ADDENDUM 1 TO ENVIRONMENTAL IMPACT REPORT

<i>Date of Publication of Addendum:</i>	July 12, 2024
<i>Date of Certification of Final EIR:</i>	March 8, 2018
<i>EIR Case No.:</i>	2015-000644ENV
<i>Project Title:</i>	Biosolids Digester Facilities Project
<i>Project Modification:</i>	Biogas Utilization System
<i>Modified Project Case No.</i>	2015-000644ENV-03
<i>Location:</i>	Southeast Water Pollution Control Plant 750 Phelps Street, San Francisco, CA
<i>Project Sponsor:</i>	San Francisco Public Utilities Commission Karen Frye, (415) 554-1652, kfrye@sfgov.org
<i>Lead Agency:</i>	San Francisco Planning Department
<i>Staff Contact:</i>	Julie Moore, (628) 652-7566, Julie.Moore@sfgov.org

Figure 2 Energy Recovery System Components Proposed To Be Removed from the Approved Project

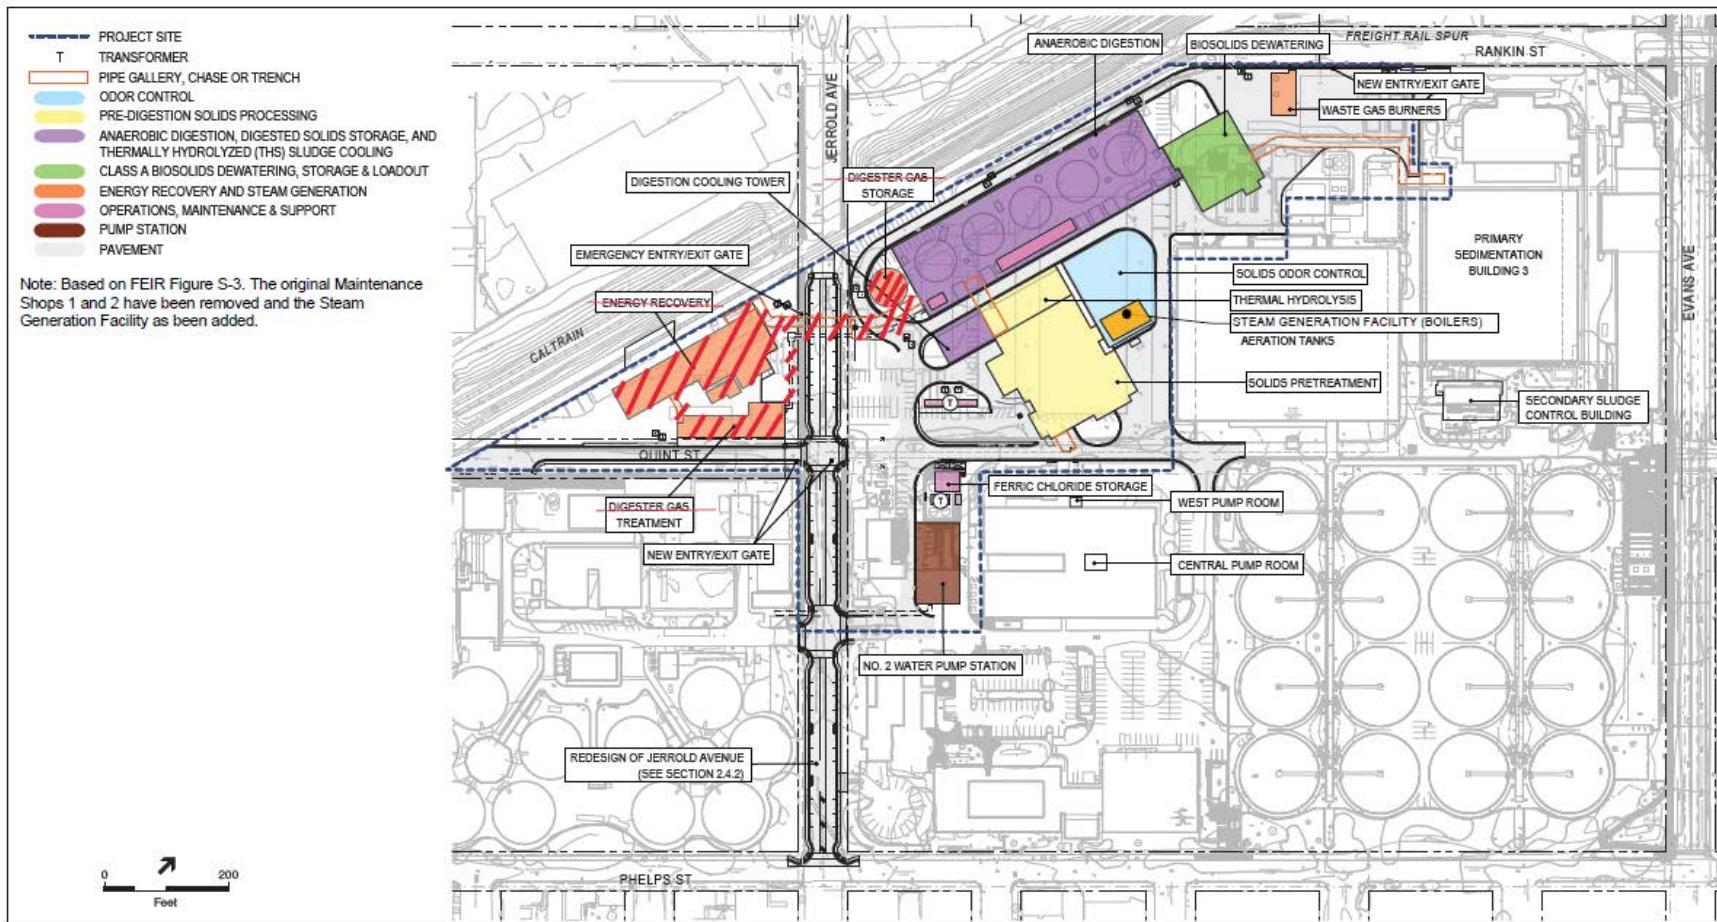
Note: Cross hatching indicates energy recovery components to be removed

Table 1 provides a summary of the energy recovery system components to be removed from the approved project and the biogas utilization system components to be added. As shown, the 57-foot-tall energy recovery building, 60-foot tall by 60-foot-diameter digester gas storage tank, digester gas treatment facility, and maintenance shop building would not be constructed. Instead, the modified project would construct the Biogas Upgrade Facility with thermal oxidizer comprised of piping, tanks, and storage container-type structures approximately 15 to 45 feet tall and a PG&E Interconnection Station and Deoxygenation System with above-ground valves and piping. Because the proposed biogas utilization system would be a less complex system with less substantial components than the approved energy recovery system facilities, construction would disturb 0.3 acres less work area, excavate 5,538 cubic yards less soil, and drill 279 to 331 fewer piles.

Figure 3 Modified Project Proposed Biogas Utilization System Components

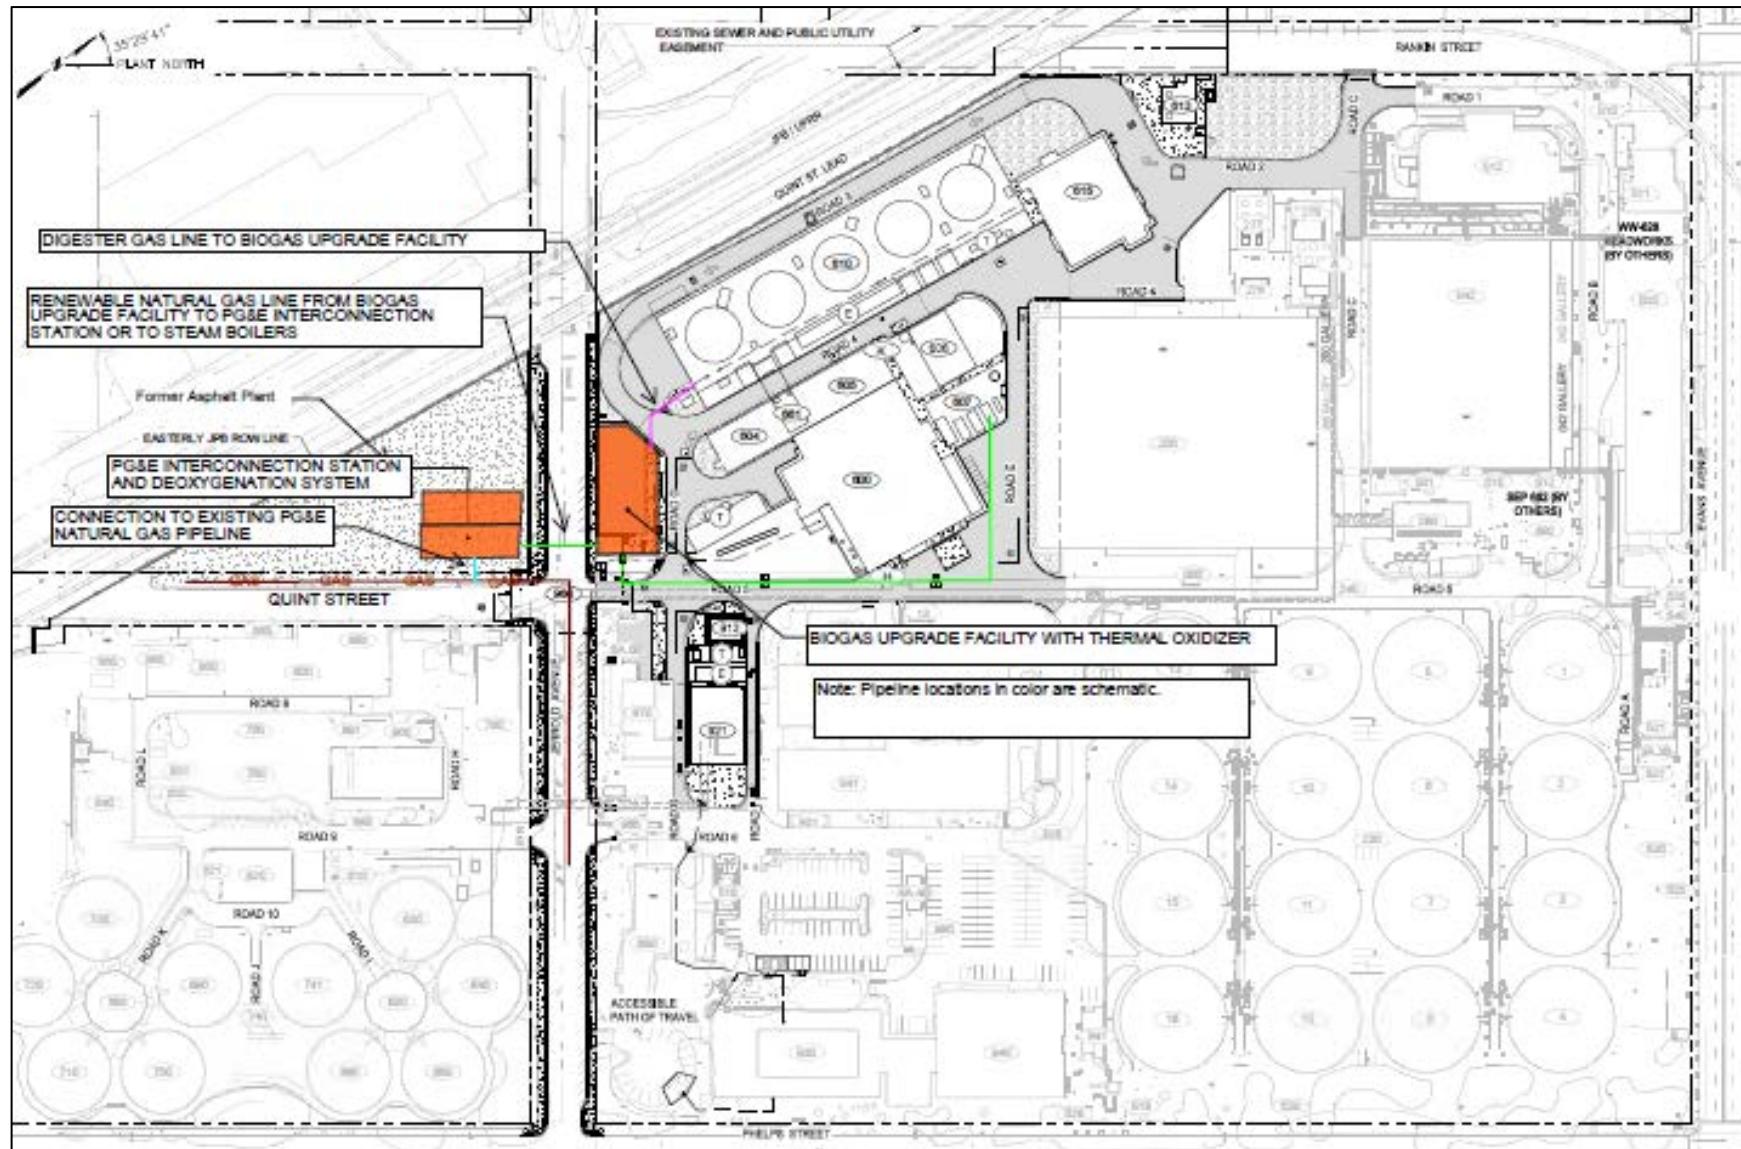
as documented in Minor Project Modification 10.³ The PG&E interconnection station and deoxygenation system would be built at the location of the former digester gas treatment facility that was part of the approved project energy recovery system. The proposed biogas utilization system facilities would be within the approved project boundary, and no additional staging areas or access points would be needed. Each of the system's components are discussed below.

FIGURE
3

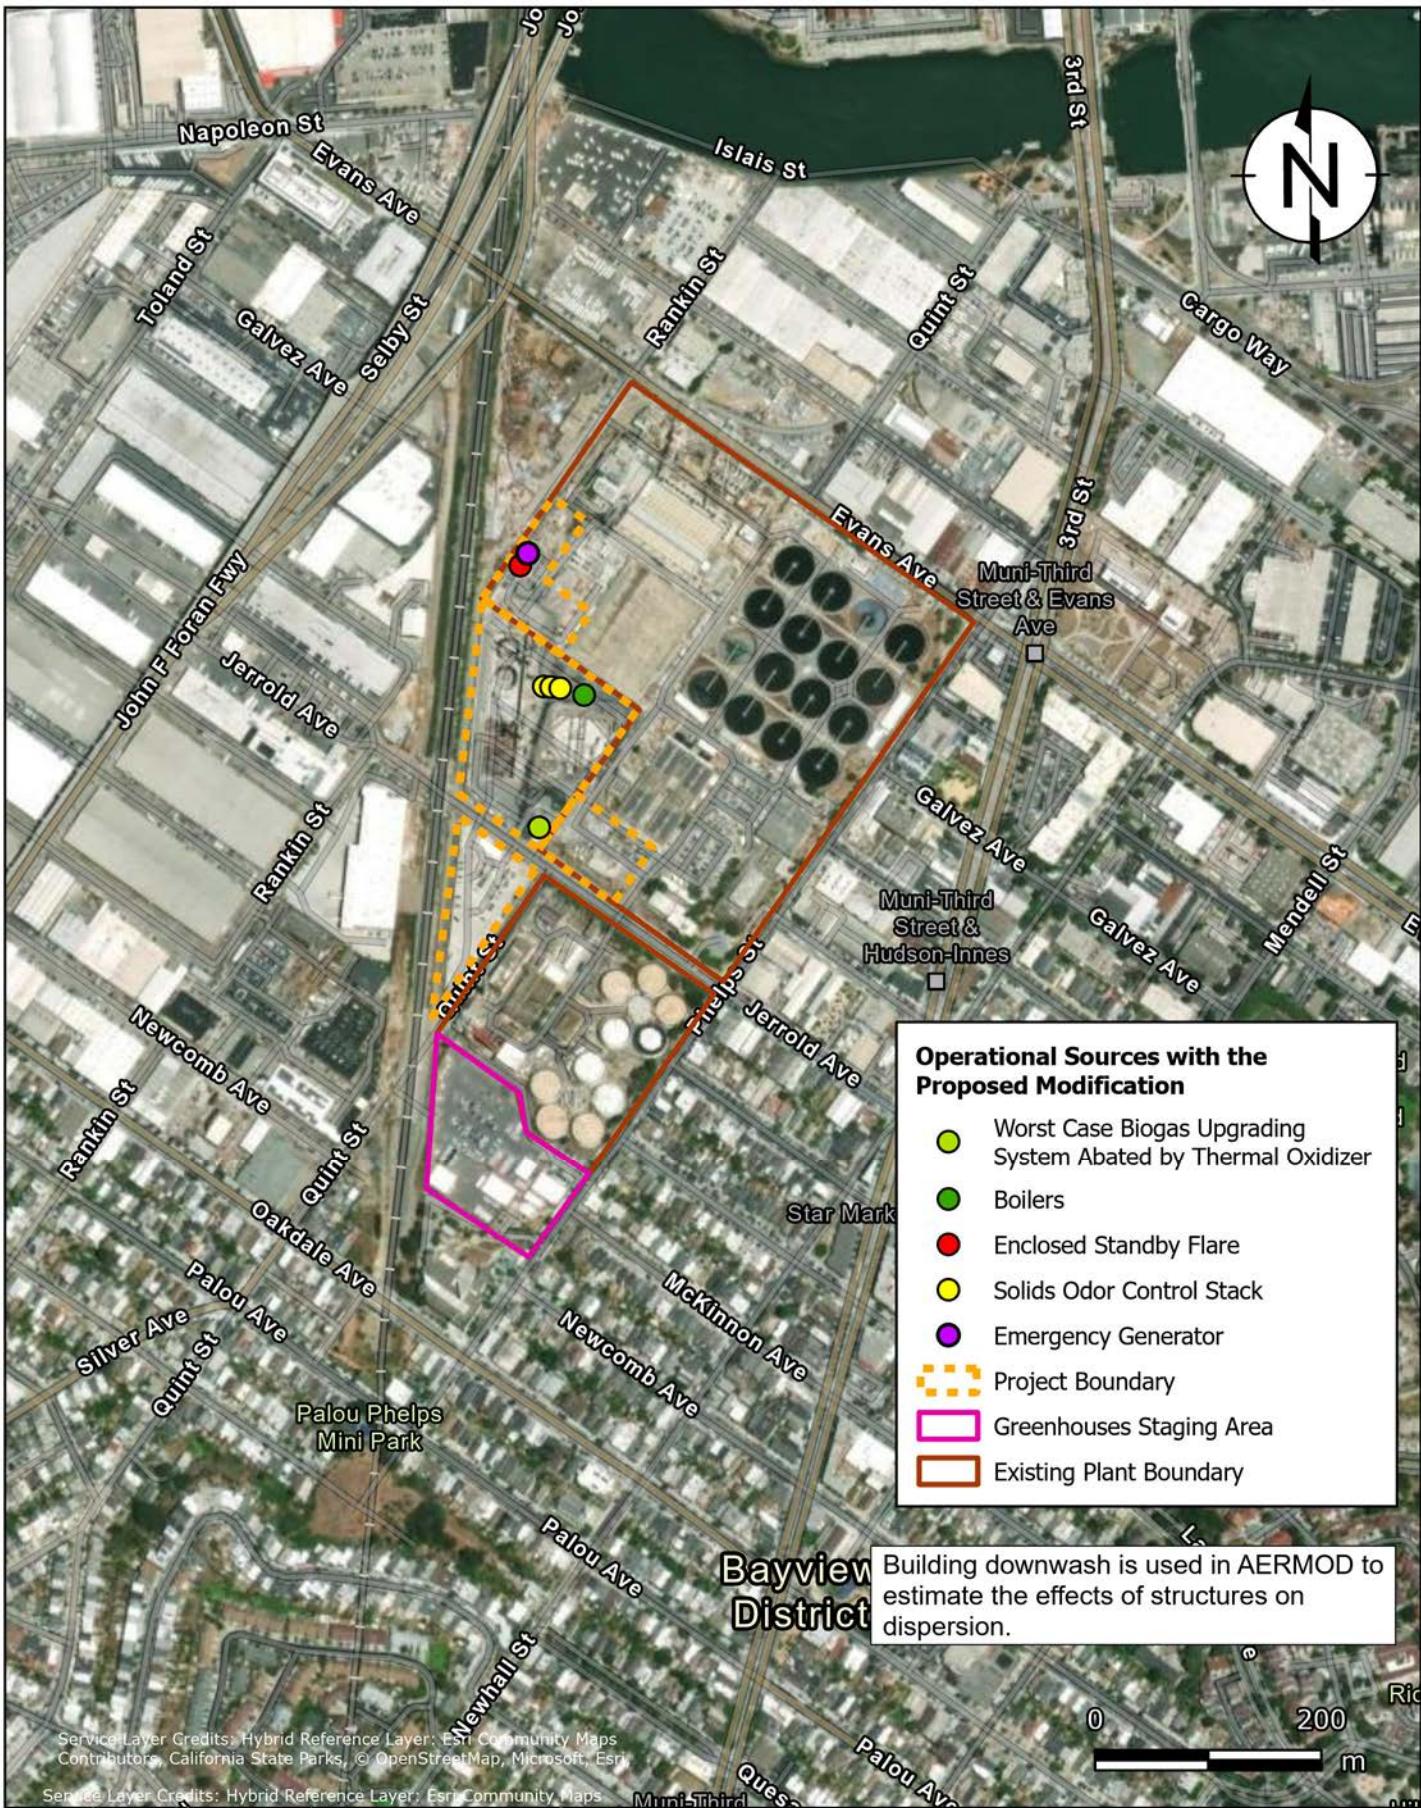
Ramboll re-modeled the Project operational sources at their modified locations and the existing sources at the facility. The modified locations of the Project stationary sources were provided by the SFPUC.⁷ Updated **Figure 3** shows the modeled locations of the operational emissions sources, which include the flares, boilers, biogas upgrade facility, and solids odor control stack. Each stationary source was modeled as a point source, with various stack heights, temperatures, velocities, and diameters. Updated modeling parameters are shown in Updated **Table E-3**. The Project operational source parameters were provided by the BDFP consultant design team.

Locations of MEIs and MEISRs from Operational Emissions
SFPUC Biosolids Digester Facilities Project with the Proposed Modification

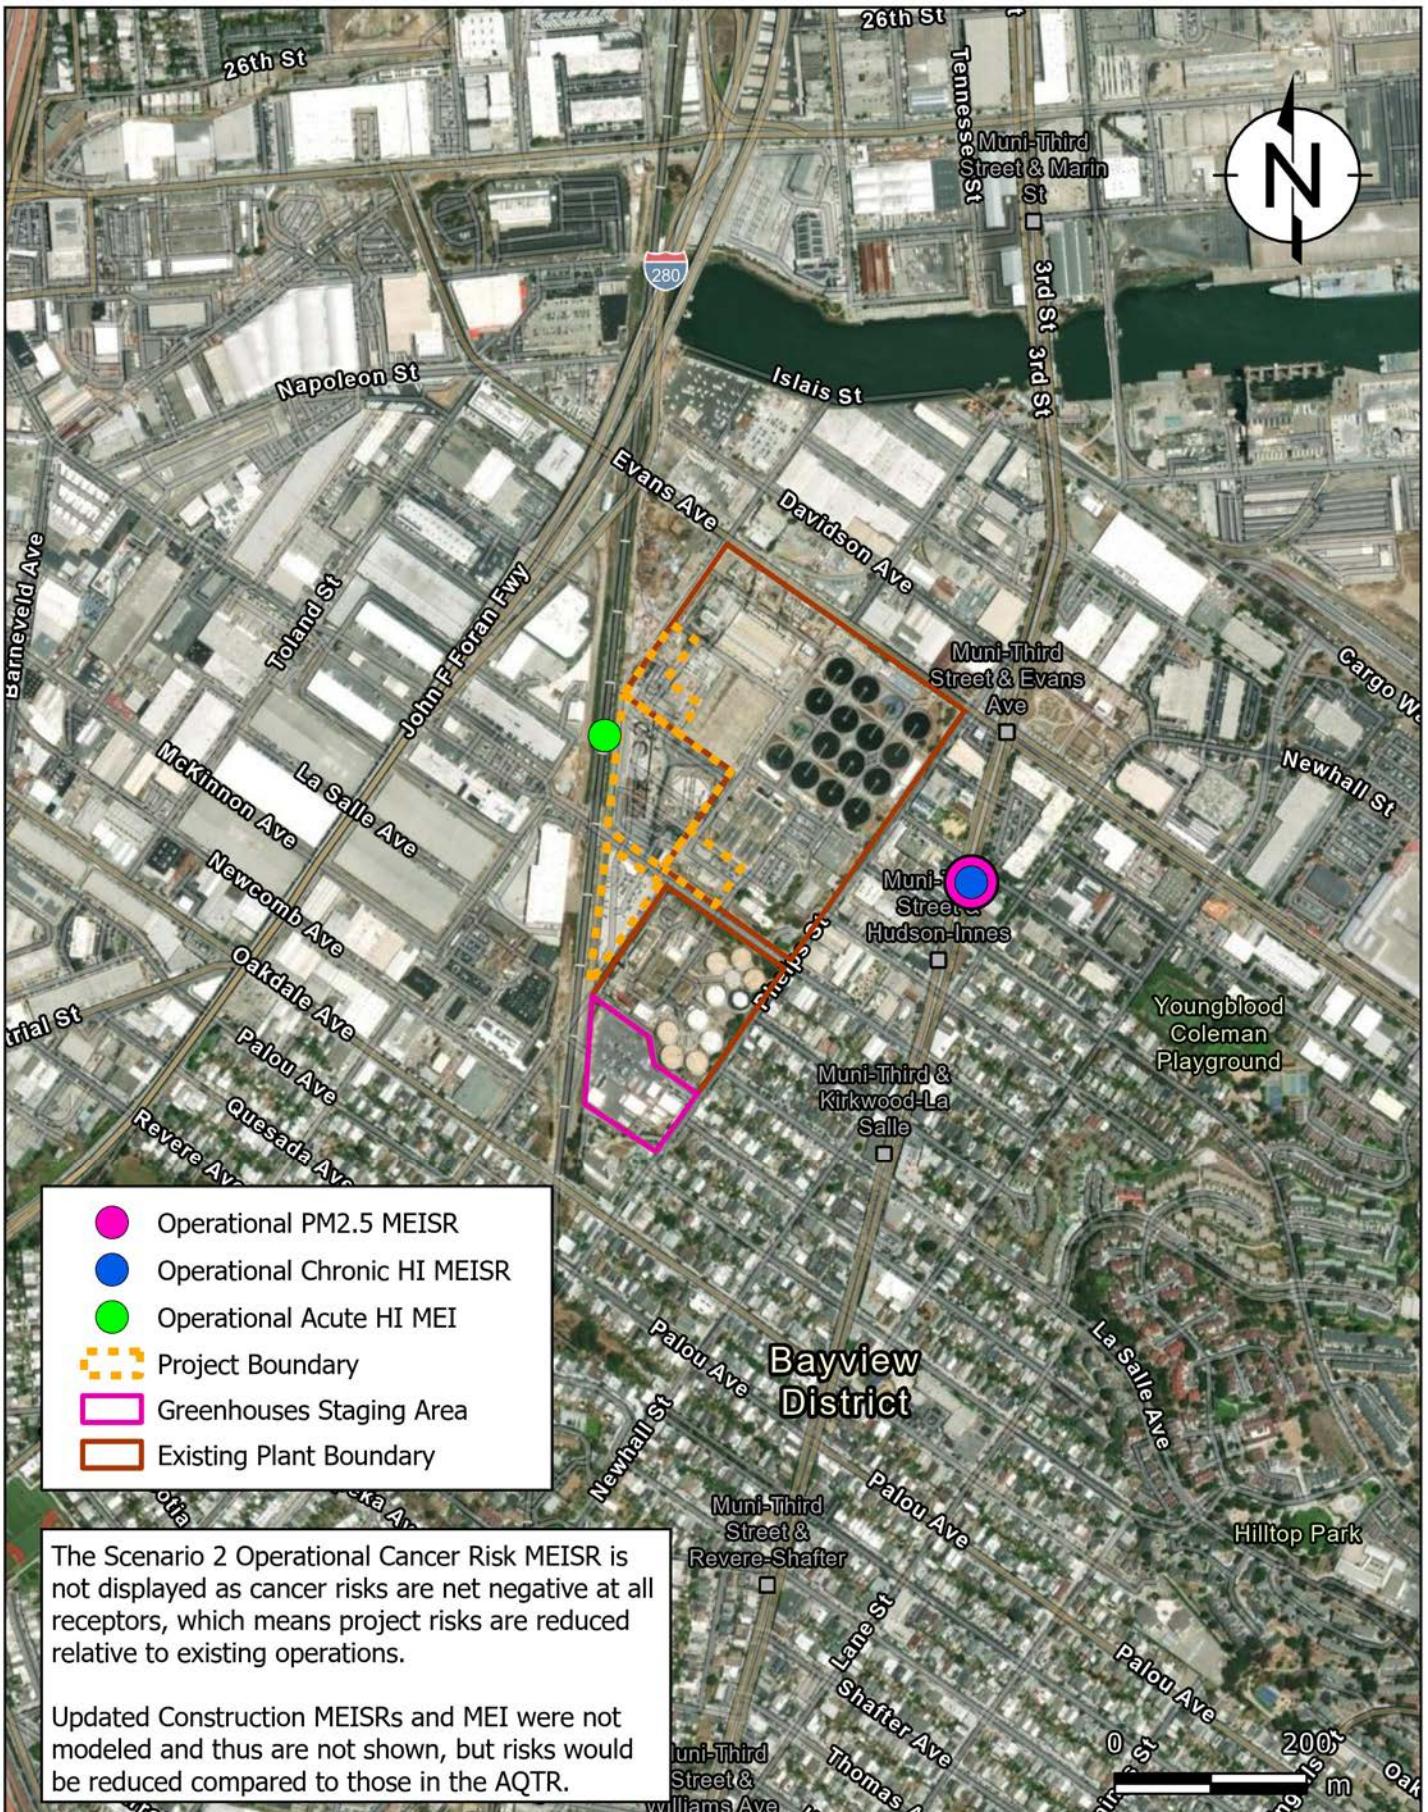
removal. As shown in updated **Figure 6**, with the proposed modification, this sensitive receptor would be located far from the project boundary, which is emblematic of a net reduction in excess cancer risk (i.e., there is a greater impact from removal of existing SEP operational sources than introduction of new sources as part of the proposed Project). Accounting for the removal of the existing equipment, the sensitive receptors with the largest reductions in net cancer risk would be those located the closest to the project. A breakdown of excess lifetime cancer risk at the updated MEISR from each stationary source for operations at their modified locations is shown in updated **Table 22**. The AQTR net Project cancer risk at the MEISR with the energy recovery system was 0.022 in a million, whereas it would be -0.009 for the modified Project.⁹ The proposed modification operations would thus represent a reduction in operational cancer risk.

Locations of all MEISRs and MEIRs discussed above are shown in updated **Figure 6**.¹³ The MEISR for excess cancer risk due to the project modification is the sensitive receptor with the highest risk over a 30-year exposure time. The MEISR for Chronic HI and PM_{2.5} concentrations is the sensitive receptor with the maximum annual average hazard index or concentration, respectively. The MEI for acute HI is the location where the maximum one-hour exposure occurs. Because of the different exposure
